## Architect's Supplemental Instructions

**Architect's ASI No:** 002

**Project:**  
Webster University  
Interdisciplinary Science  
Building

P0011 - Level 01 Area A/B Underfloor Plan - Plumbing

**P0011**

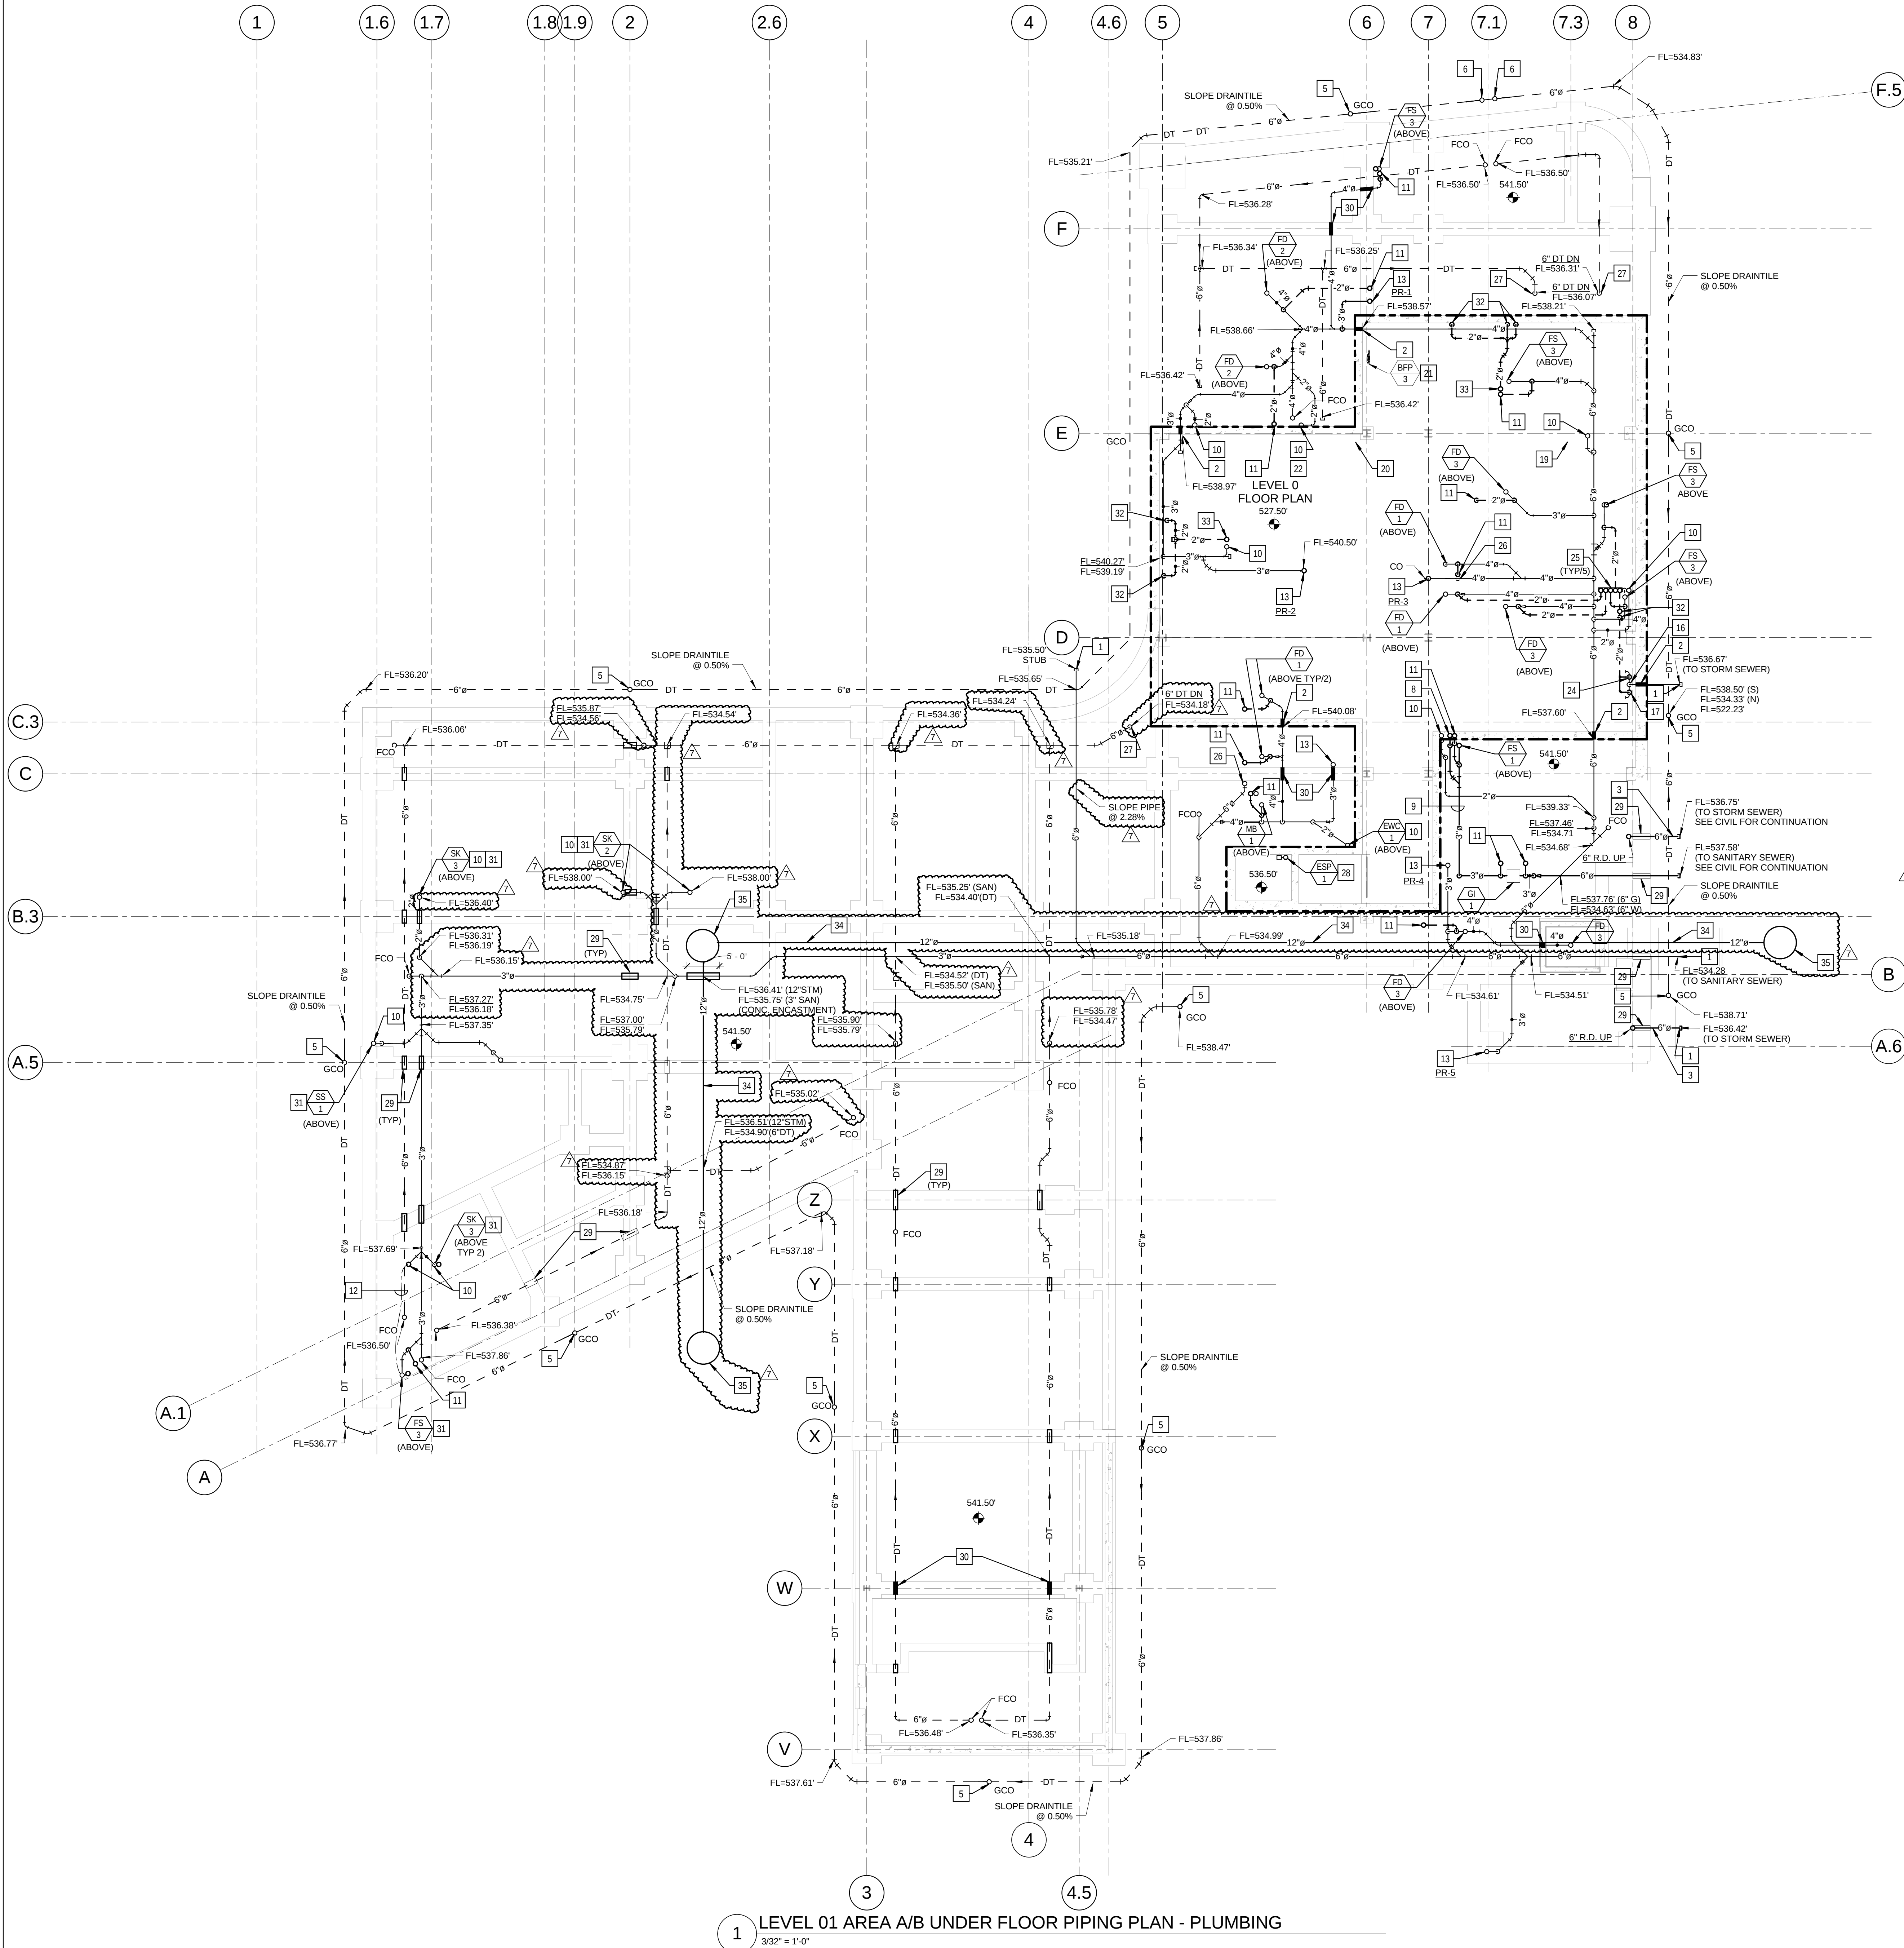
ASI-002 is being issued for the purpose of clarity on the installation of drain tile and sanitary sewers. Due to conflict with the drain tiles, sanitary sewer truck line and the proposed 12 inch storm sewer and manhole, modifications have been made to the flow lines and alignment of these items to eliminate those conflicts. Refer to drawing P0011 for associated changes.

- 33 2" VENT UP.
- 34 12" STORM SEWER FOR REFERENCE ONLY. REFER TO CIVIL DRAWING C500 FOR CONTINUATION.
- 35 NEW MSD CONCRETE MANHOLE BASE FOR REFERENCE ONLY. COORDINATE WITH CIVIL.
